**22 George Street, Leichhardt
Greenland Australia**
Bulk Excavation Plan

2.0 RESPONSES TO SEPP 65 REVIEW

The clarifications and amendments to the previously issued design proposal have been prepared in direct response to the issues raised by Leichhardt Municipal Council and in particular in the correspondence as outlined in the sections as follows:

3.0 RESPONSE TO EMAIL CORRESPONDENCE FROM ADELE COWIE, DATED 20TH AUGUST 2014 REGARDING OVERSHADOWING DIAGRAMS

2.7.6 THE AMENITY OF THE PROPOSAL FOR IT'S USERS. BLOCK B

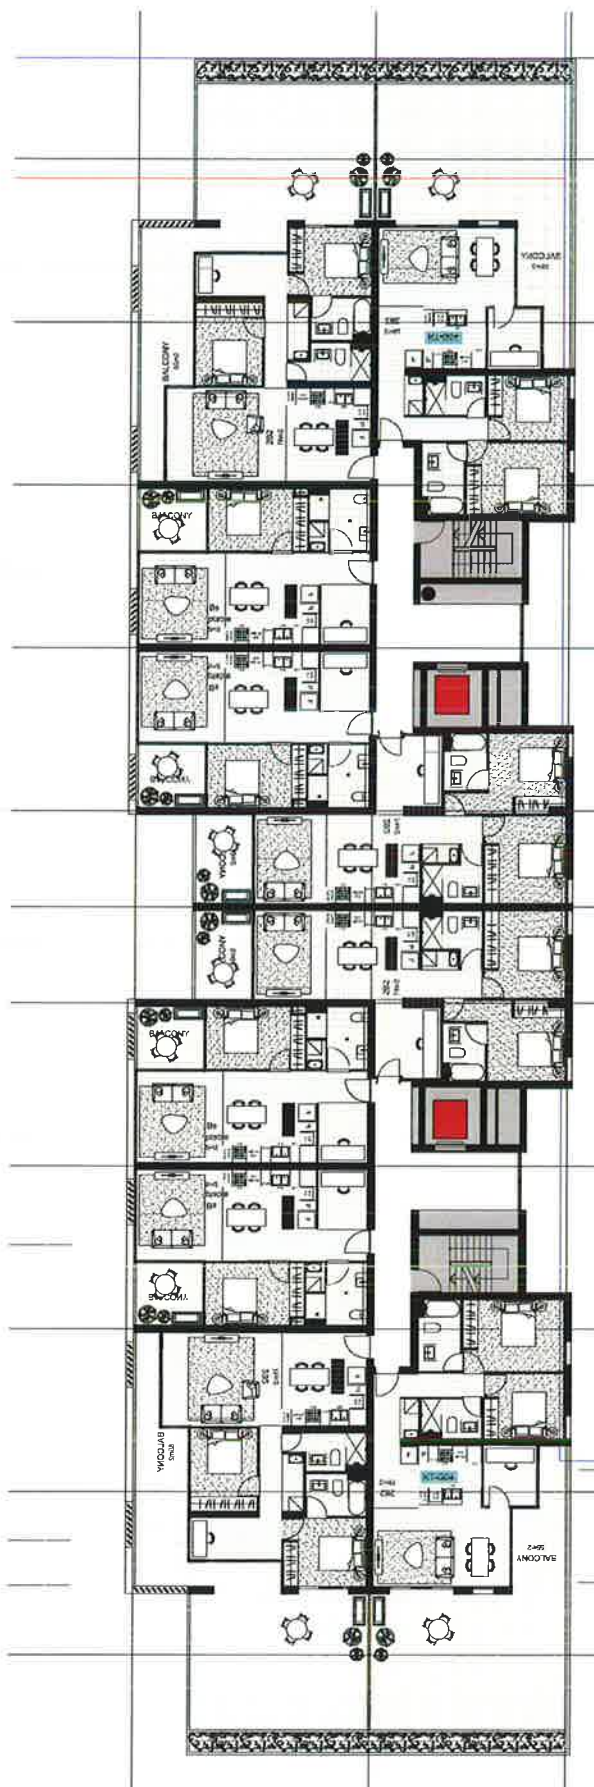
/ Previously in block B at ground and 1st floor level there were 2 bedroom units wrapping around an inset balcony. This has now been refitted to allow a front facing balcony and increase levels of privacy.

/ The corner units at 4th floor level to the north side of the building have been amended by omitted the inset balconies and allowing access on to the adjoining terrace without going through the bedroom.

/ The corner units from ground to 1st on the south elevation have been amended so that the study can be provided with natural daylight.

2.7.5 THE AMENITY OF THE PROPOSAL FOR IT'S USERS. BLOCK D

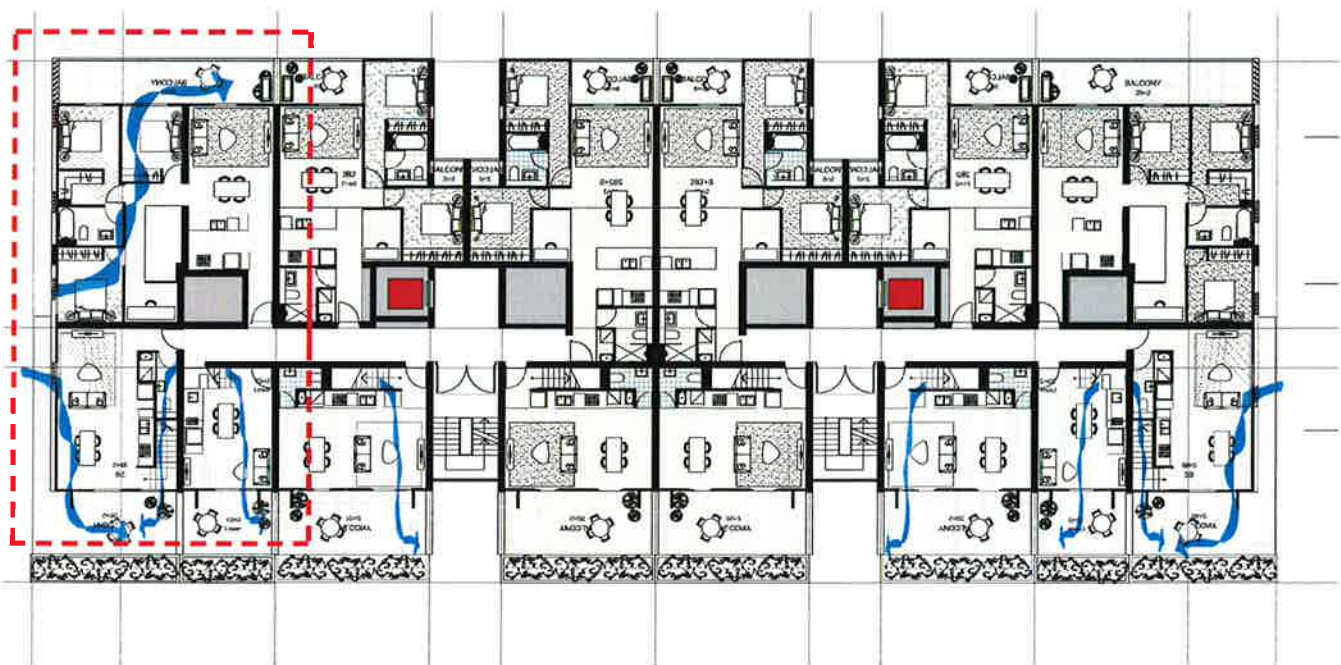
Internal arrangement of the units, a high proportion of units will rely on artificial light and ventilation. It is recommended that planning changes be investigated to vastly reduce this reliance.

In order to provide a higher proportion of units with access to natural light, cross ventilation and increased privacy amendments have also been to units in blocks B and D

In block D there was previously a 3 bedroom unit to the corners of block D at levels 4 and 5. These have been revised and are now two 2-storey walk-up units.

This allows cross ventilation to the 2 bedroom corner units through the facade and cross ventilation to the 1 bedroom units via the use of a vent in the roof.

2.5.2 RESOURCE AND ENERGY USE AND WATER EFFICIENCY STAIRWELLS

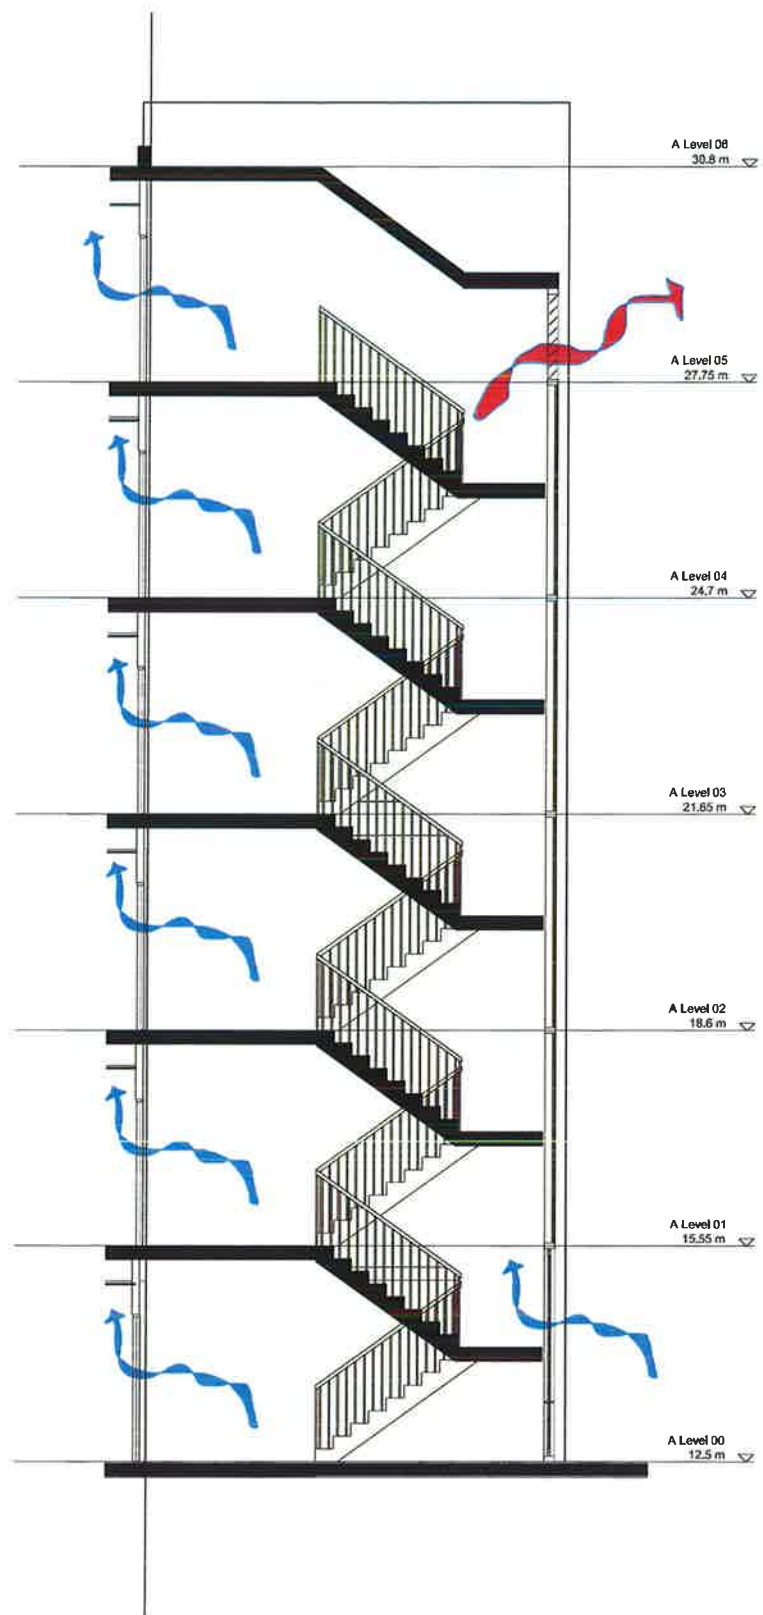
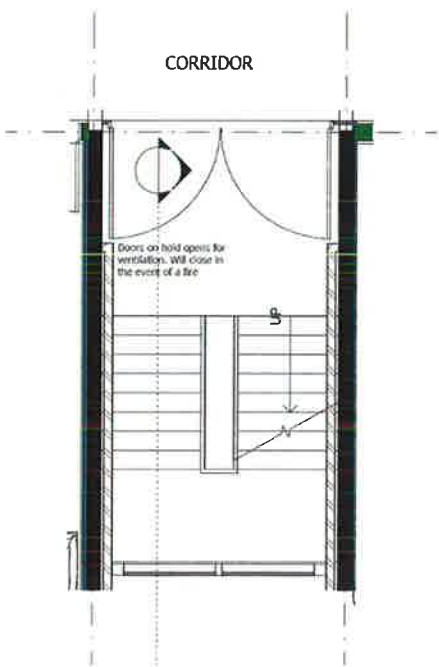
The nature of the stairwells built form is unclear on the drawings with regard to the windows and roof, ventilation and heat gain.

7 Each of the stairwells are fully glazed from ground level to roof and have glazed louvers to provide adequate ventilation through the lobbies and corridors.

The lobbies are also set back from the facade line and as a result as shaded by the neighbouring apartment

2.5.1 RESOURCE AND ENERGY USE AND WATER EFFICIENCY SUNSHADING

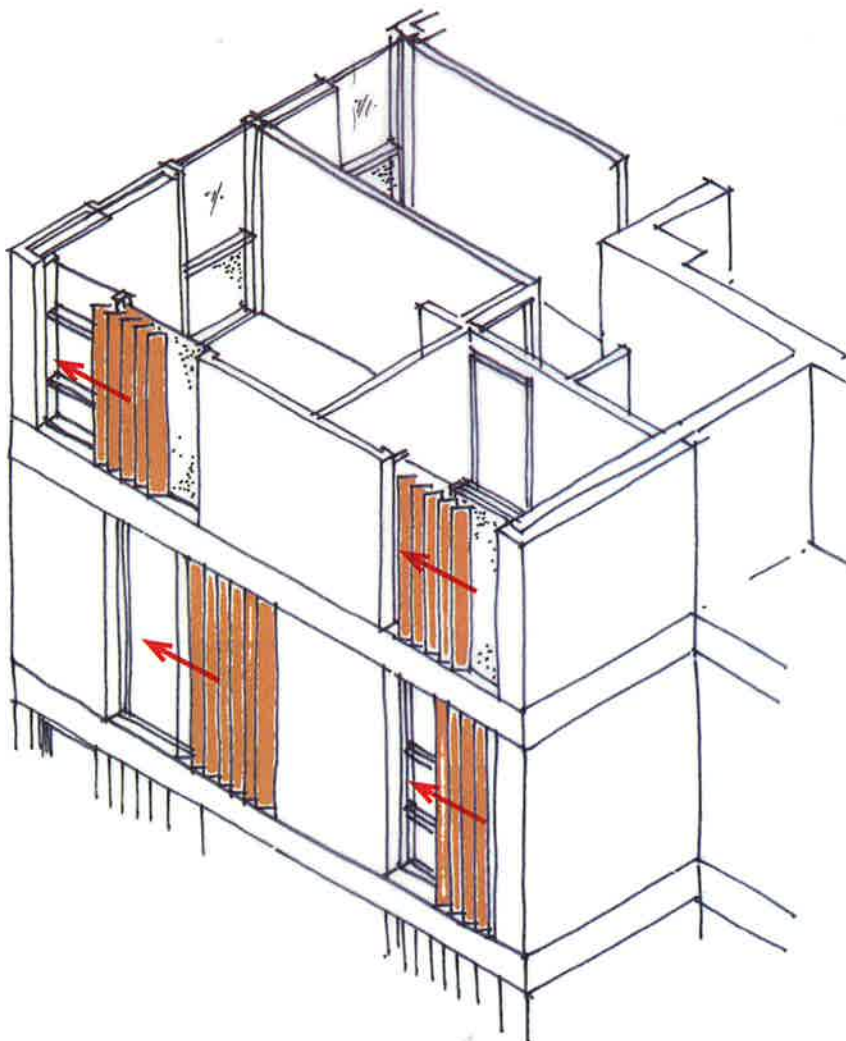
Sun-shading has been provided in many instances however there are some inconsistencies.

Louvers in most cases are operable and therefore can be shifted to provide solar shading where its required and limit the sun/heat loads.

2.5.0 RESOURCE AND ENERGY USE AND WATER EFFICIENCY VENTILATION

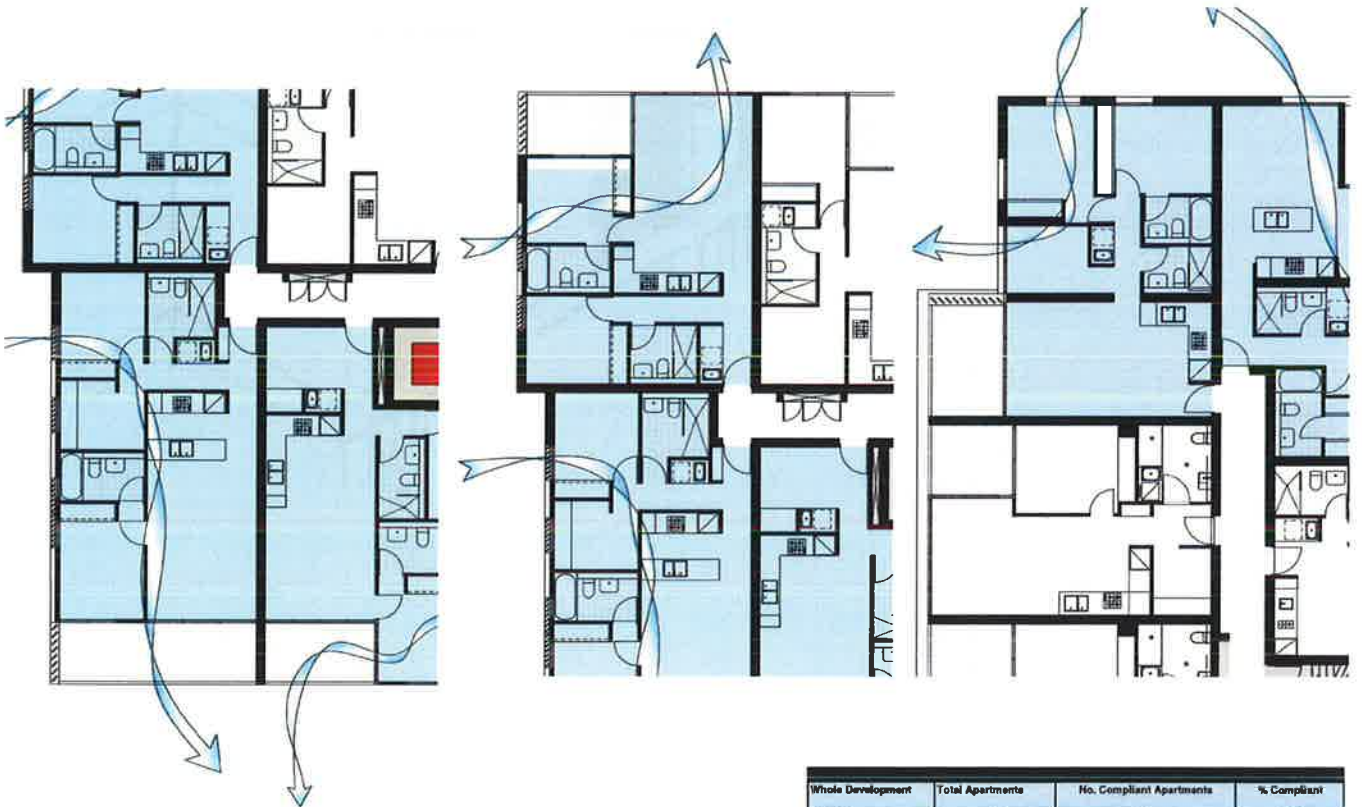
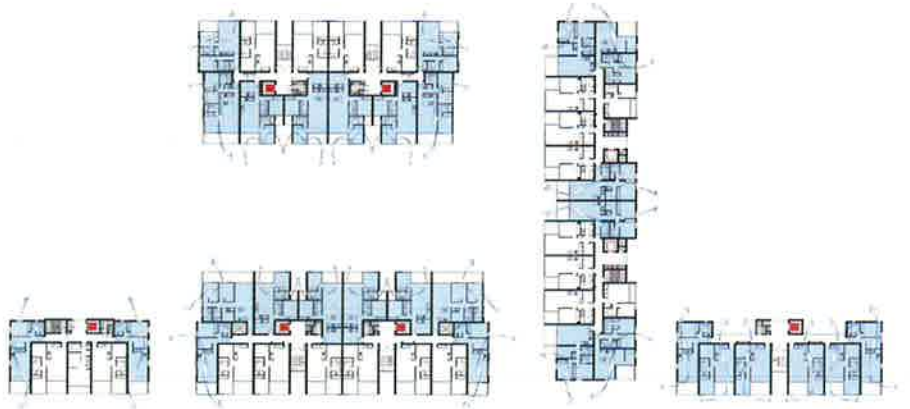
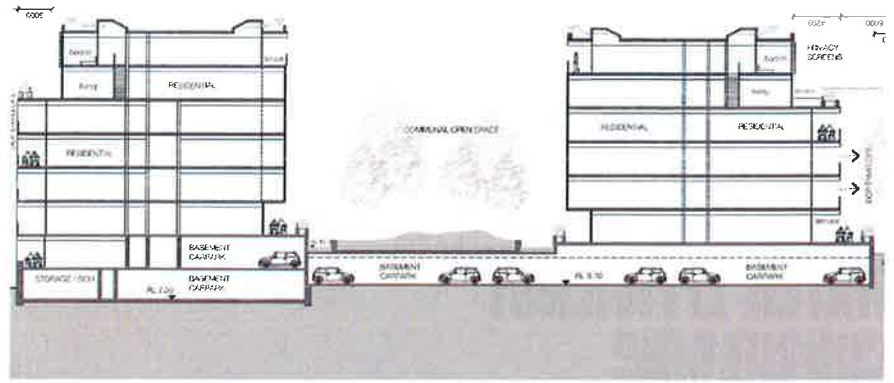
62% of the units are cross ventilated this would still fall short of an optimum number which should be much higher given the density of the proposal.

The total number of cross ventilated units has been increased to 69% this has been achieved in the following ways:

The use of clerestory windows to the roof levels of all blocks excluding block C

The use of a plenums at high level to each corridor at each level for clock C

The floor plate design is articulated to maximise the number of corner apartments for cross-ventilation. The articulation also increases the number of dual aspect apartments on the upper level and provides natural light and ventilation for lift lobbies.

2.3.5 BUILT FORM OF THE PROPOSAL COMMUNAL SPACE

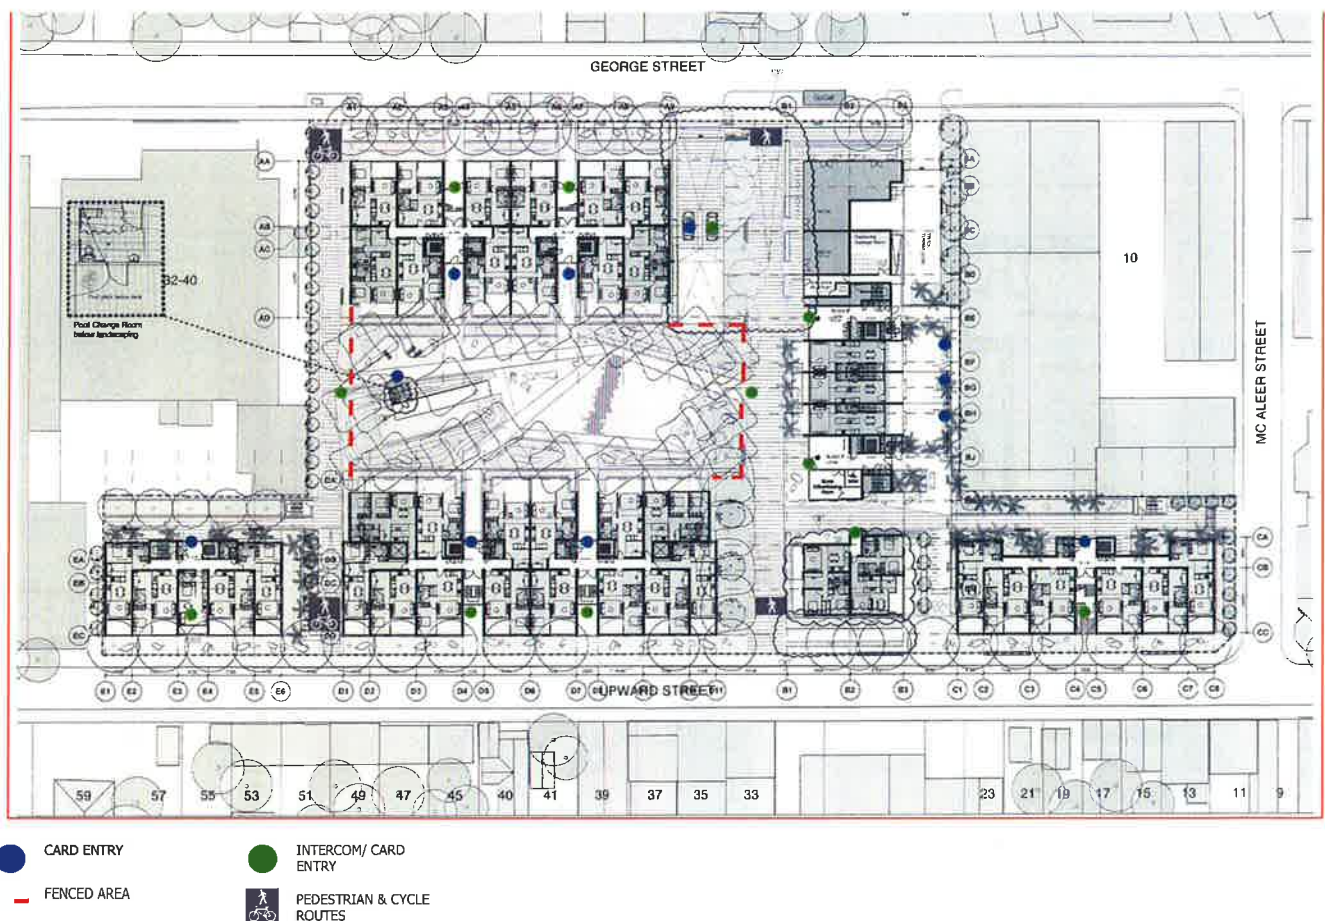
The detailed design of the private gated access from the links into the communal open space will be important to its success.

/ The area surrounding the pool will be fenced off and will have private gates access from the links into the communal open space.

BLOCK E GROUND FLOOR

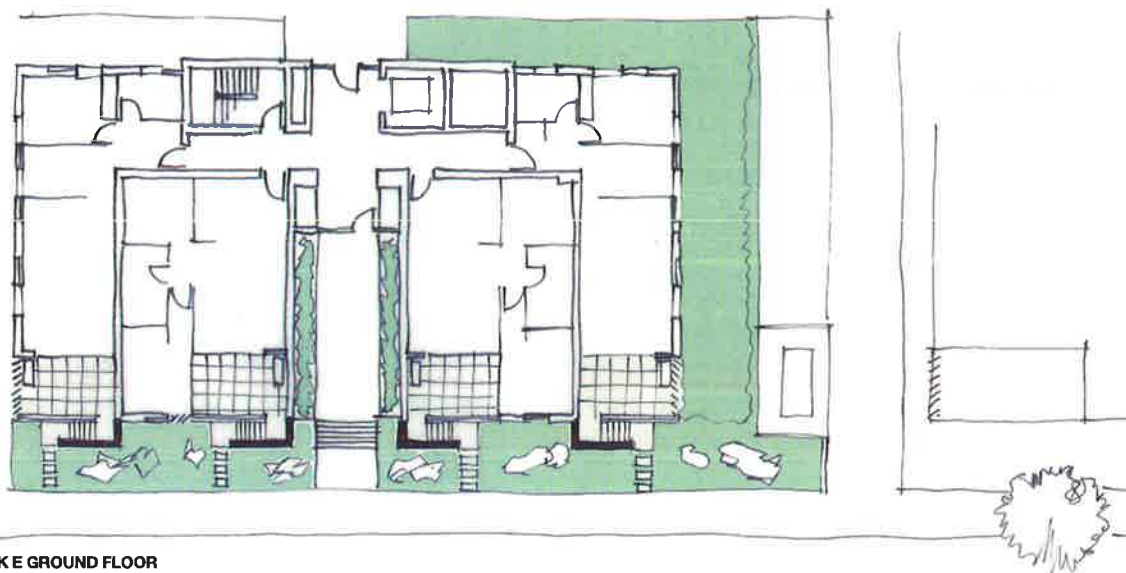
The lower ground floor units facing Upward street would be provided with alternate direct street access rather than forcing all entry through an enclosed corridor

Block D and E both have the lower ground floor entry due to the typography of the site

Block D would be difficult to achieve a street access due to the height of the building which is set by the 1:100 year flood event. The apartments would require a significant number of steps between street level and apartment ground level.

Block E sits at the top end of Upward Street and is beyond the flood risk zone, therefore it may be possible to provide these 4 units with street access. However, we would not recommend this approach for the following reasons: 1) Due to the shape and size of the building there seems little point as the travel distances through the central lobby to your front door would be minimal. 2) The architectural approach would also be different to that of the other buildings within the development and 3) The security risk would also be greater due only one line of defence.

2.3.2 BUILT FORM OF THE PROPOSAL. BLOCK B LOBBIES

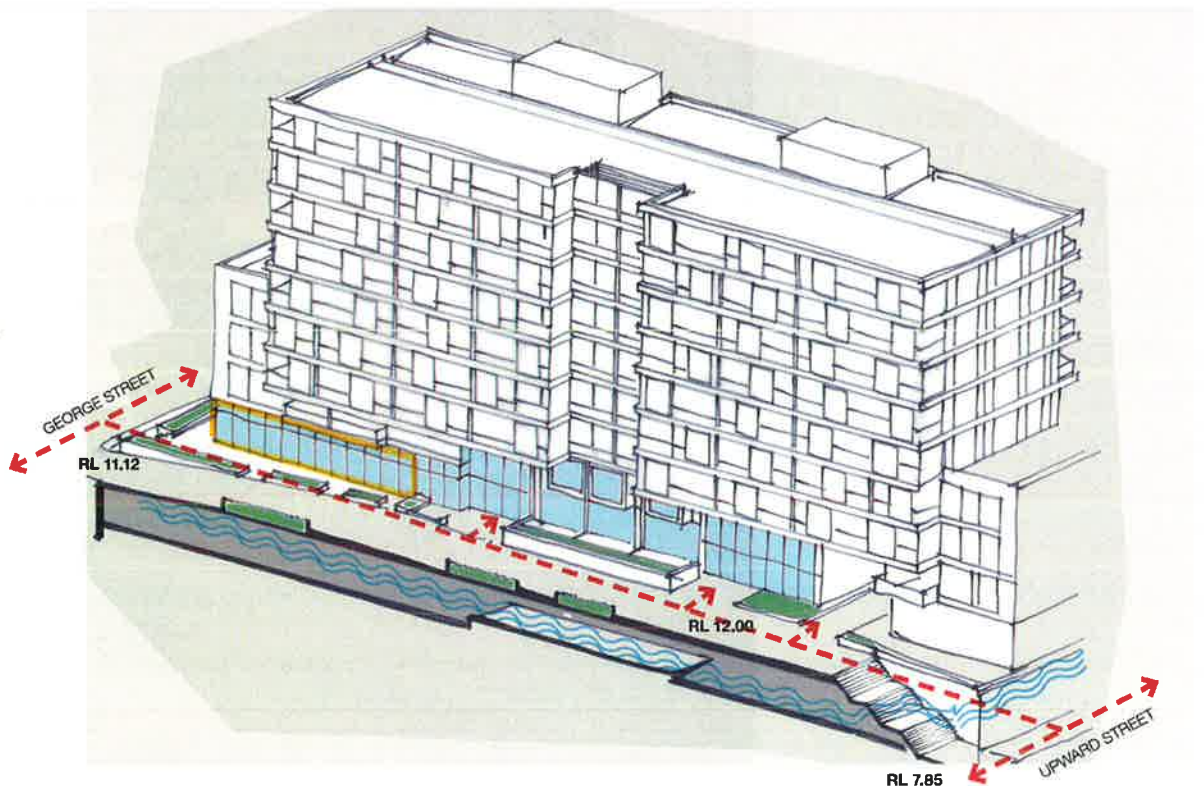
The entry and common lobbies to Building B would be best placed to the street rather than almost central to the site and accessed from the pedestrian through-site link.

During the design stage it was considered that the lobbies to Building B could be positioned along the both Upward and George Street.

However, there are a few reasons why we decided against this approach: 1) If we were to have common lobbies facing the street then for the layout above ground to work efficiently it would require long travel distances to reach a central core from the street. 2) There is a significant level change between Upward and George Street, which should the lobby be along the street, would affect the efficiency and planning of the units. 3) The elevated level of Block B along Upward Street is also to be able to deal with the risk of flooding to any common lobby and/or apartment. 4) The retail/ cafe is located in a prominent position along George Street to define the edge and main entrance into the site. This coupled with the centralised lobbies to block B gives real activity to the pedestrian link between Upward and George Street. 5) The building entrances located off the pedestrian street will bring a degree of supervision of this area and will activate the pedestrian link. This will have a positive impact on the overall security of the public pedestrian link and will provide an additional layer of surveillance in line with OPTED principles.
